# PRODUCT NOTICE # 8-4-10-1

Direction of UART RTS# and CTS# signals reversed

ConnectCore Wi-i.MX51

Part Number	Description
30011032-01	ConnectCore for i.MX51 Development Board

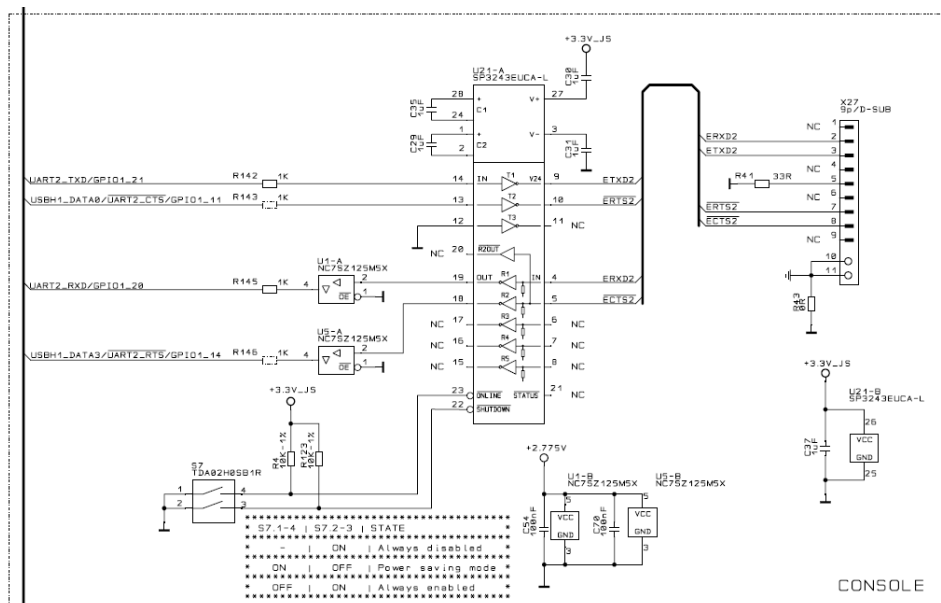
The RTS# and CTS# handshake signal (UART1/2/3) direction is reversed on the development board for the ConnectCore Wi-i.MX51.

Please note that this issue cannot be addressed using an external patch cable.

This affects development boards with Digi P/N 30011032-01 (PCB) only.

The schematics below provide a correct reference implementation with additional level shifting (+2.775V) capabilities.
